ITEMS RECEIVED AFTER THE PRODUCTION OF THE REPORT
FOR THE PLANNING COMMITTEE
TO BE HELD ON 12 JUNE 2025

MATTERS ARISING FOR COMMITTEE**COMMITTEE DATE : 12 JUNE 2025**

| Location: Cliff Haven Residential Home, 10 Clive Crescent, Penarth | |
| Proposal: Conversion to 3 Apartments with side and rear extensions and other alterations. Proposed alterations throughout the site to include the addition of retaining walls and alterations to levels. | |

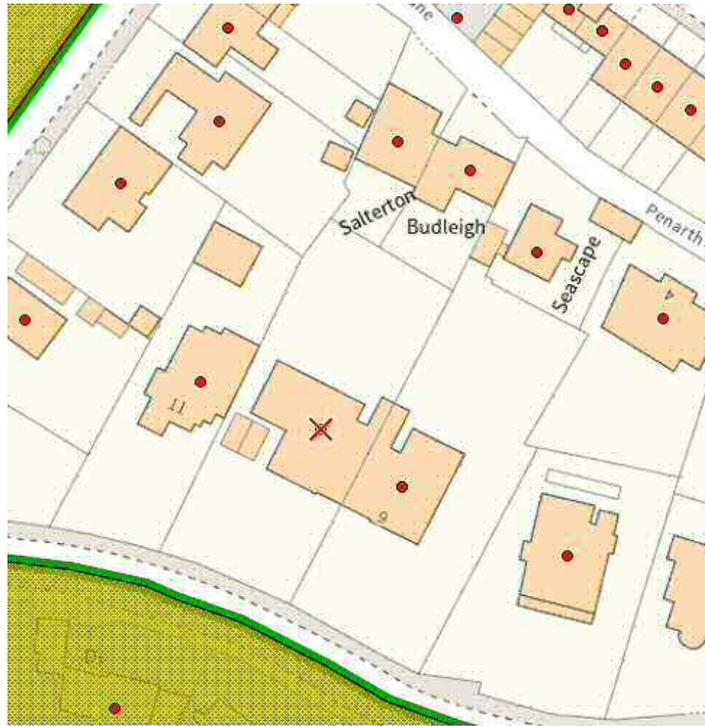
Three emails received, dated 3, 5 and 6 June, 2025.

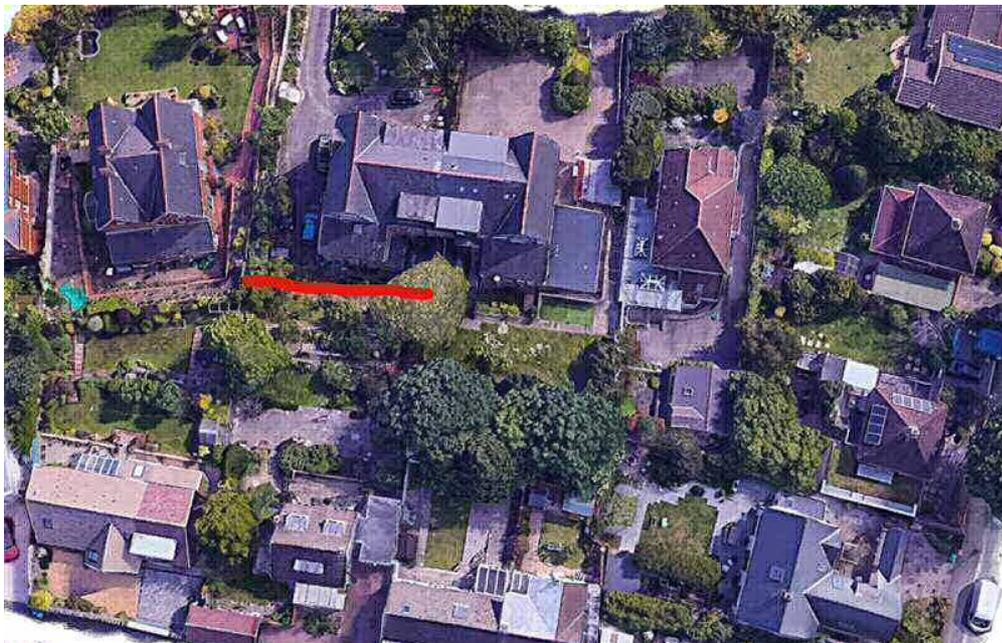
- Aerial image hides detail of boundary due to tree foliage.
- Plans submitted with application are erroneous as they omit a single storey outhouse to the rear of no. 9.

- Plan also shades in the existing house rear to run to my side boundary and it does not. Omission of inset house line gives bias to the rear extension and felling of the Walnut Tree.

- Comments regarding consultation are noted. However, consultations have been carried out in accordance with legislation.
- Comments with regards to being a close neighbour are noted and it is recognised that the Authority have based an assessment on neighbour impacts off the Ordnance Survey maps, which is the most up-to-date mapping available, which indicates the positions of neighbouring boundaries as follows:

However, it is acknowledged that satellite images would concur that the rear garden for Seascope does differ to that outlined in the Ordnance Survey maps. It is unfortunate that the maps are not up-to-date, however, this is outside the scope of control of the Authority. However, it is recognised that the assessment on this neighbour needs to be amended. The following satellite image indicates the rough position of the rear boundary for Seascope, as per the understanding of the Authority and as agreed by the neighbour in the email dated 6th June:

The proposed rear, second floor extension would be located a sufficient distance from the boundary to ensure no harmful impact to this neighbour's garden. In addition, whilst it is noted that there are habitable room windows proposed on the second floor, it is considered that given its distance to the boundary, in addition to the acute angle, there would be no harmful overlooking. It is also noted that this neighbour's garden is already overlooked by existing windows on neighbouring properties.

Therefore, whilst the position of boundaries is noted, it is considered that the overall assessment on neighbouring impacts would not differ to those as referenced in the Officer's report.
